BARANGAROO SOUTH

Stage 1B Public Domain Modification S4.55 Development Application Report

Mod Application Overview

HICKSON PARK SOUTH ENTRY
DETAIL PLAN

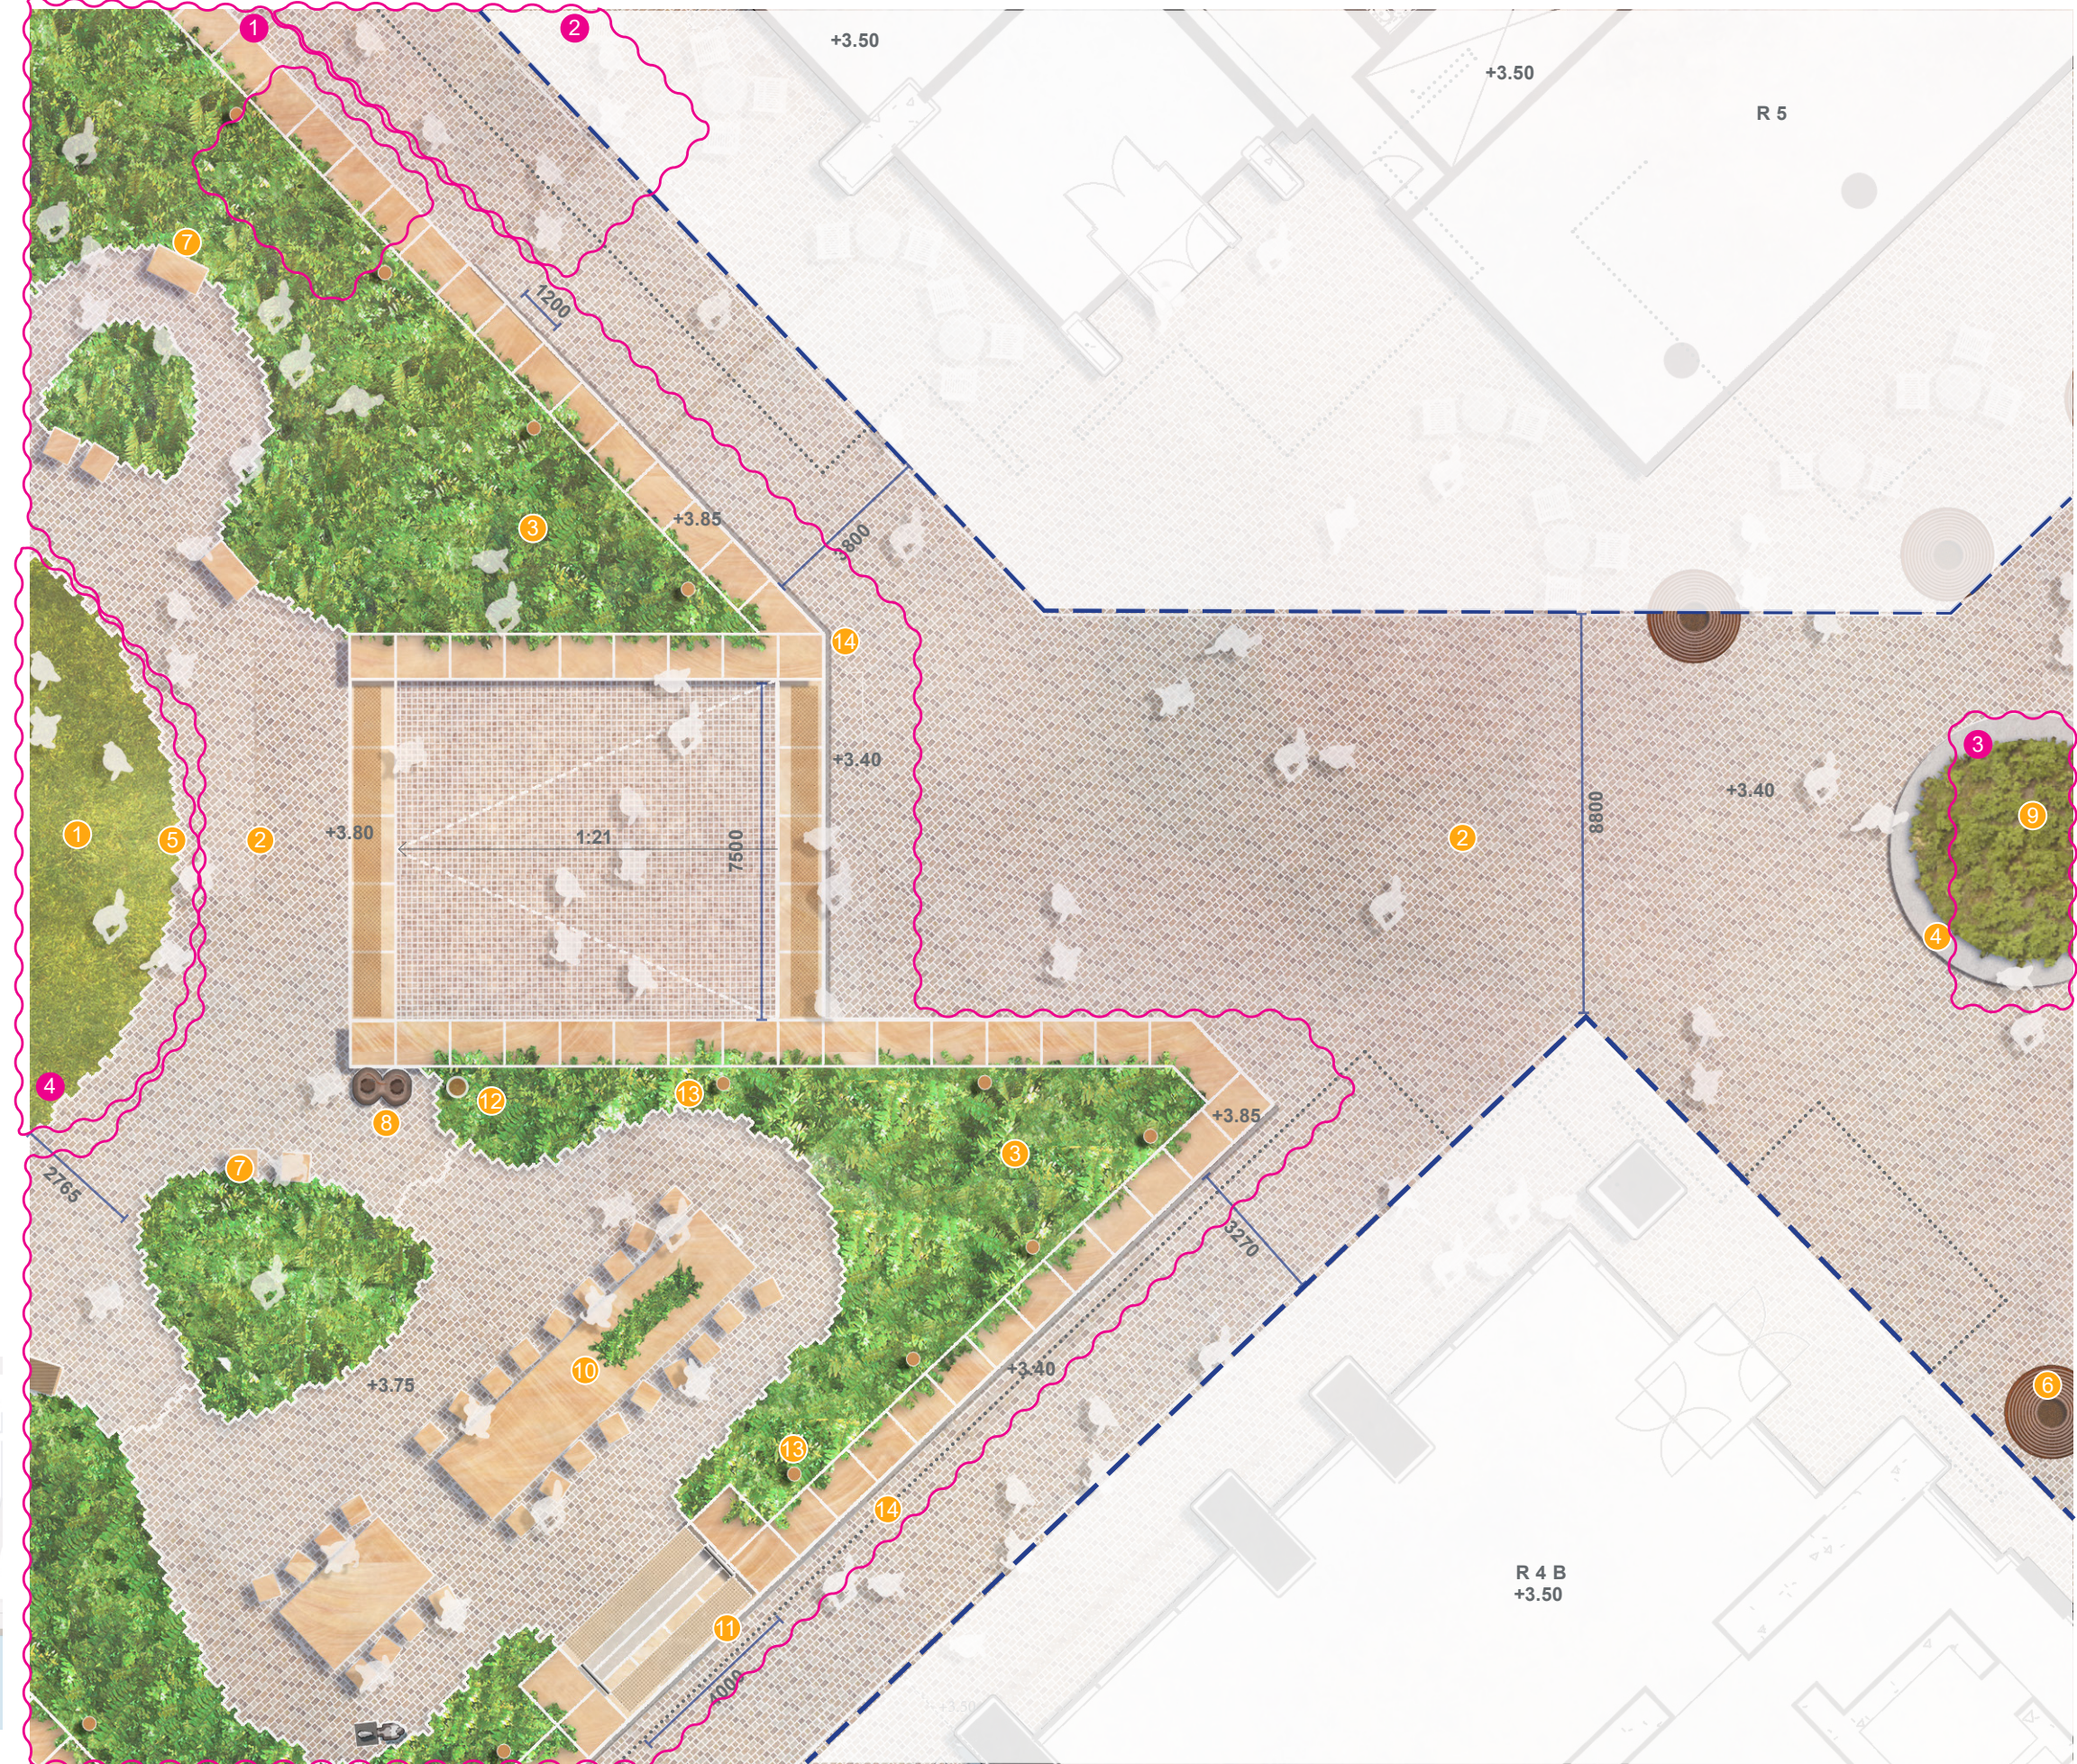
- Amendment cloud
- 1 Increase planting area within the park, change of geometry and remove 1no. access stairs.
- 2 Remove ramp and sandstone wall due to proposed Hickson Road levels
- 3 Remove timber top for Watermans Quay raised planter seating
- 4 Levels changed due to proposed Hickson Road levels

HICKSON PARK WEST ENTRY
DETAIL PLAN

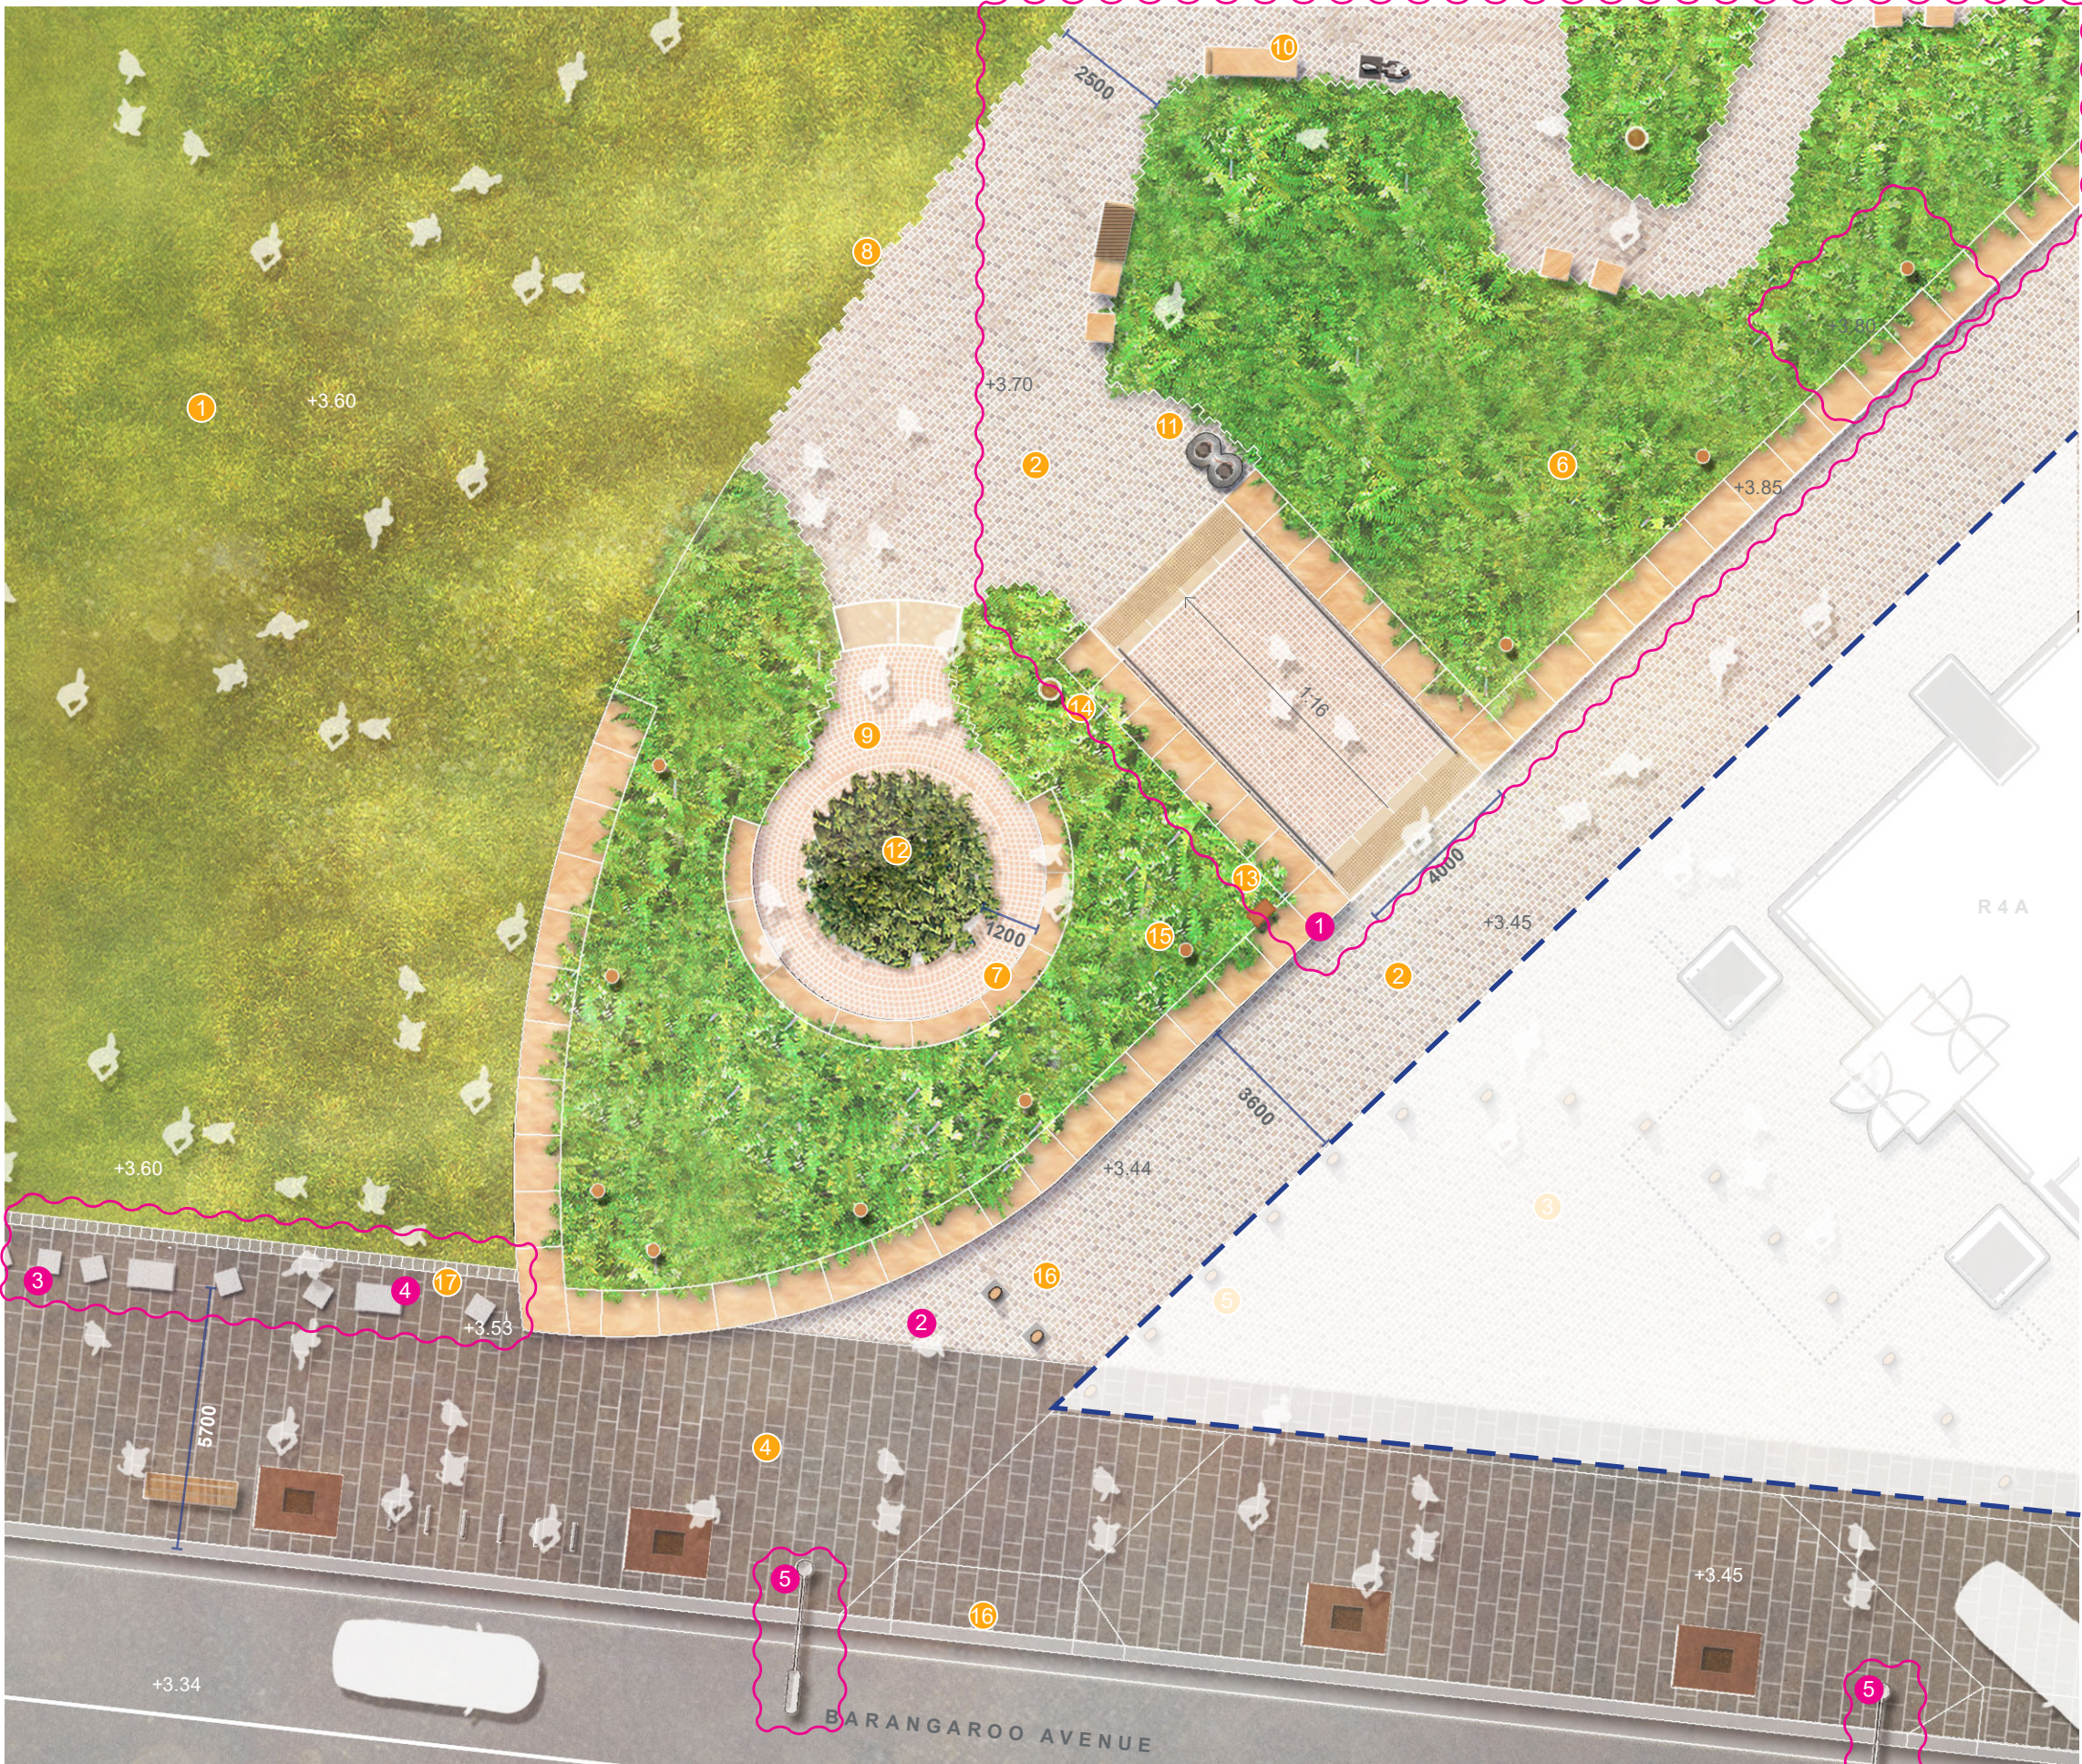
- Amendment cloud
- 1 Increase planting area within the park, change of geometry and remove 1no. access stairs.
- 2 Remove porphyry paving to City of Sydney transition as per consent requirement B23
- 3 Sandstone paving strip changed to City of Sydney paving along Hickson Park
- 4 Sandstone bollards changed to concrete & setout amended.
- 5 B23Additional smart pole

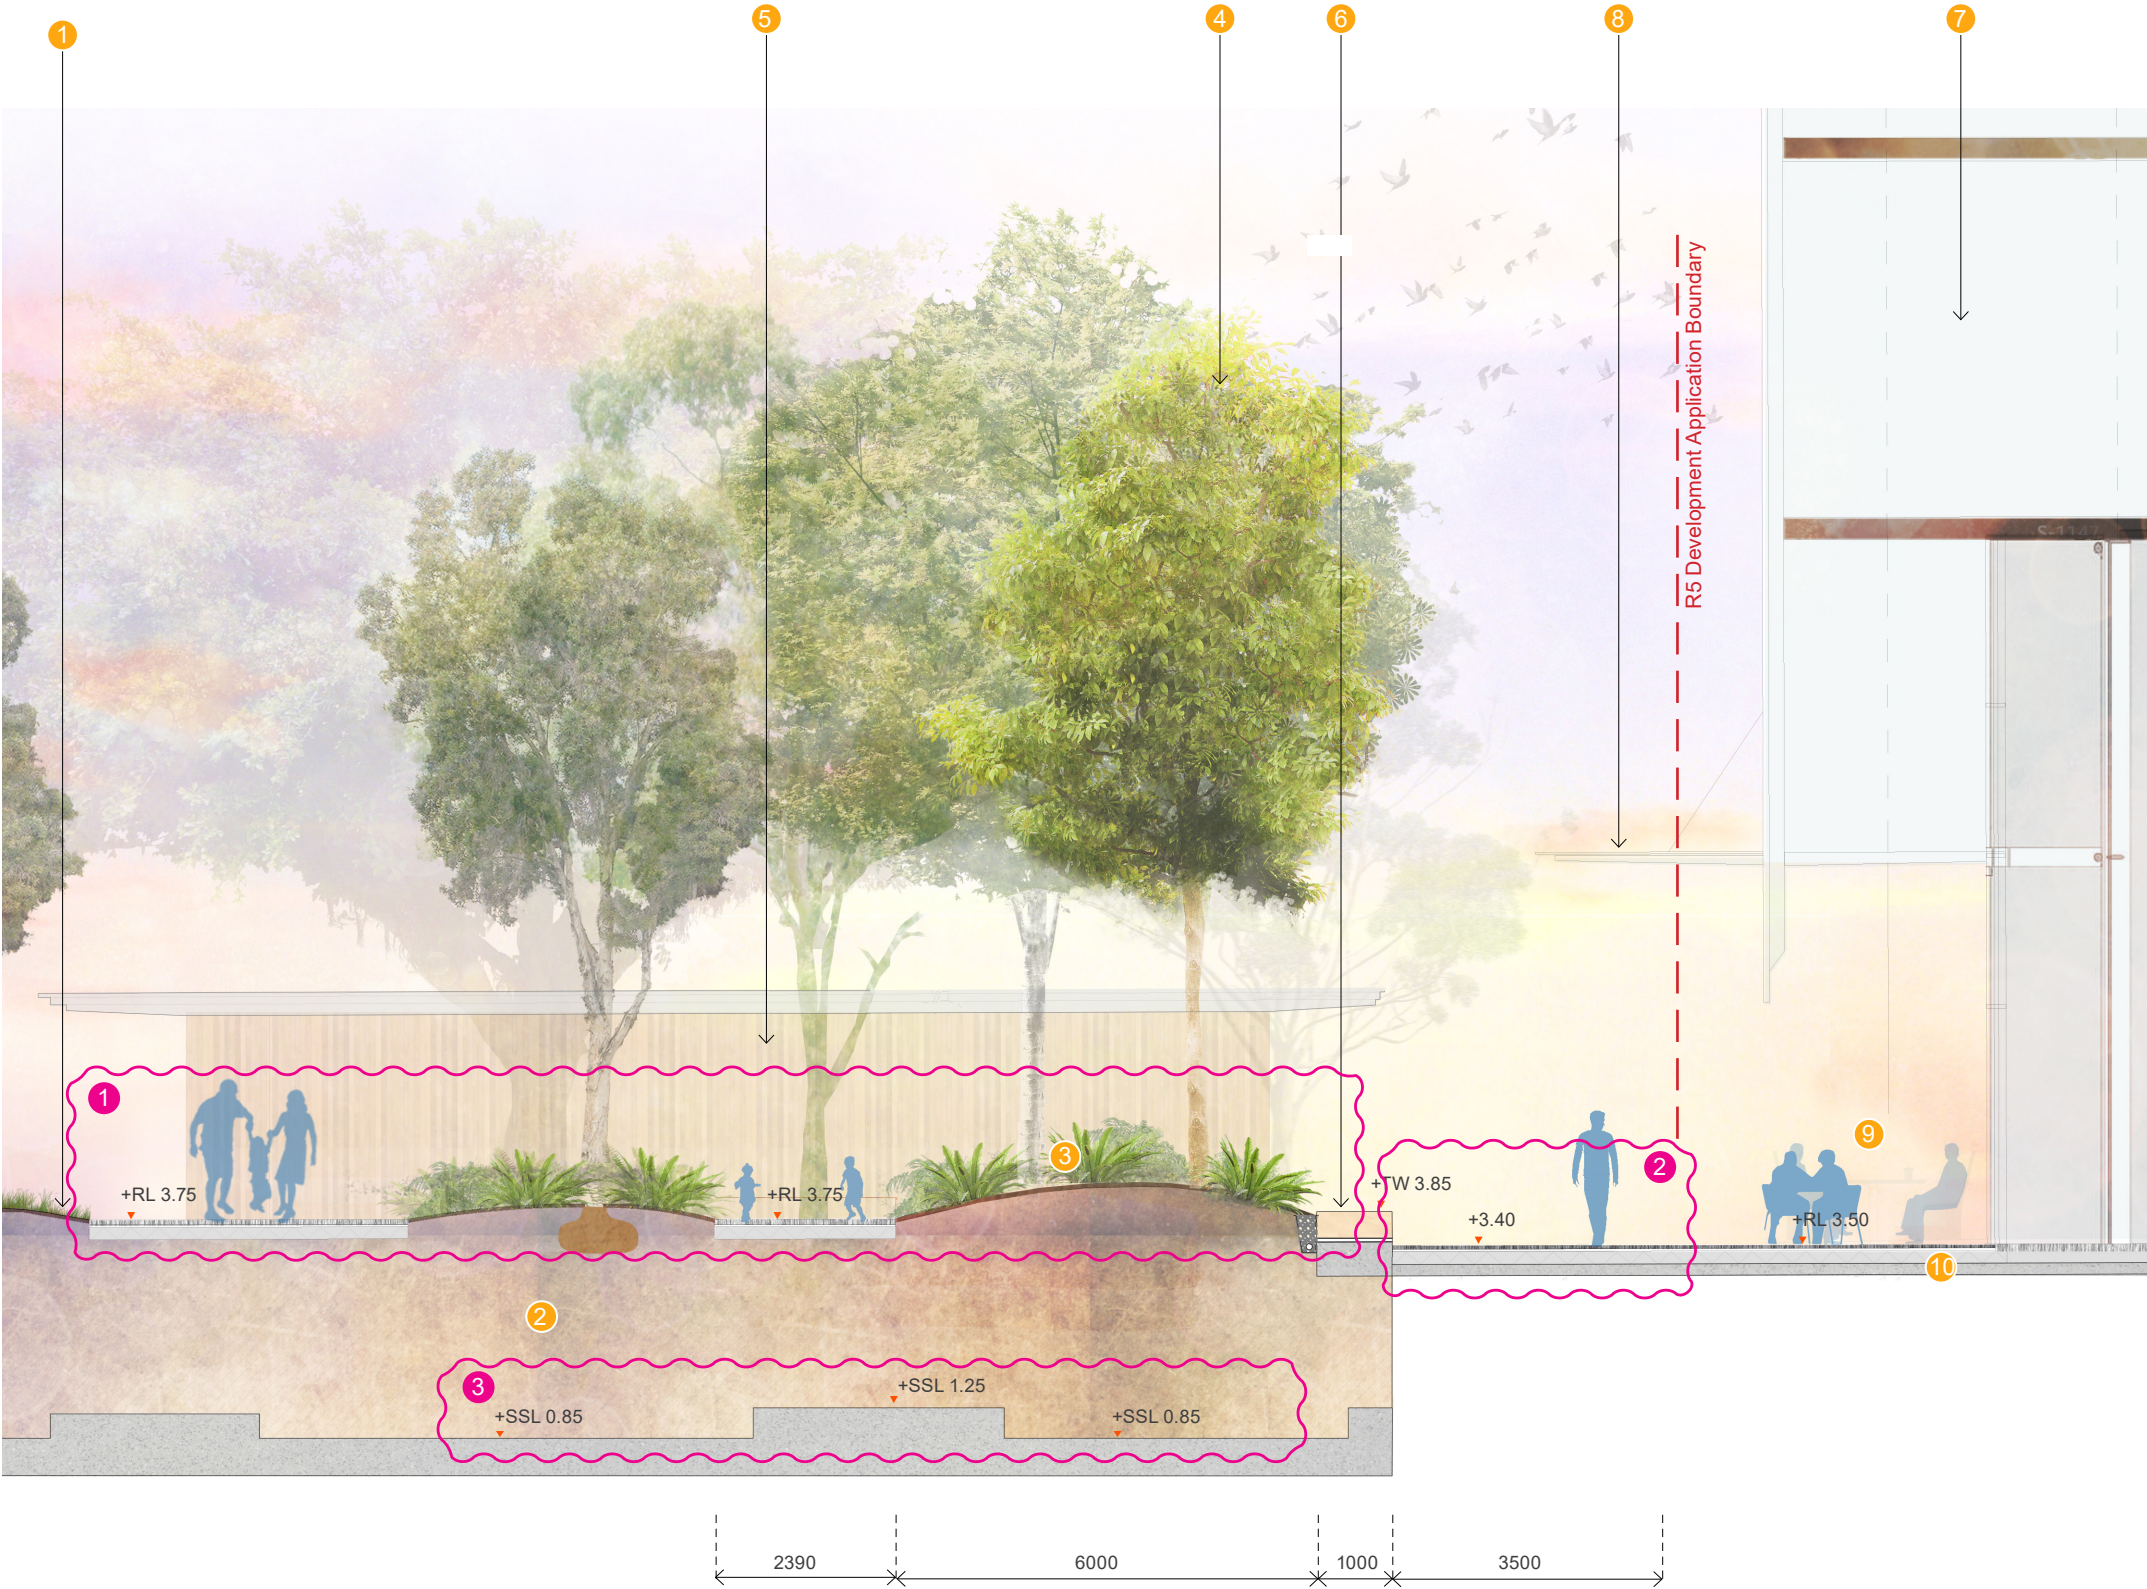
- Amendment cloud
- 1 Sandstone paving strip changed to City of Sydney paving along Hickson Park
- 2 Sandstone bollards changed to concrete & delete bollards to East park edge
- 3 Levels changed due to proposed Hickson Road levels
